Proposal #25: 5735-04-60
Sparta - Tomah
Hazel West Rd to Hollister Ave
STH 16
Monroe County

This is Addendum No. 01, which provides for the following:

ADDENDUM NO. 01

5735-04-60

Addendum No. 01
ID 5735-04-60
Added Sheet 4A
June 1, 2017

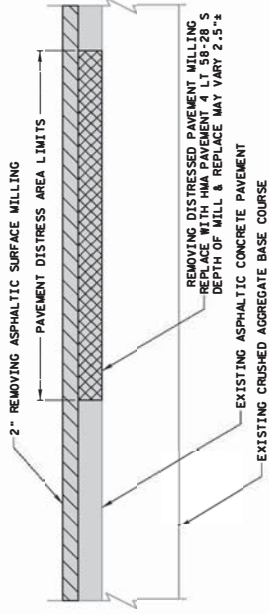
Added Plan Sheets	
Plan Sheet	Plan Sheet Title (brief description of why sheet was added)
4A	Removing Distressed Pavement Milling (To clarify bid item)

Added: Sheet 4A

PLAN VIEW

SECTION AA

REMOVING DISTRESSED PAVEMENT MILLING
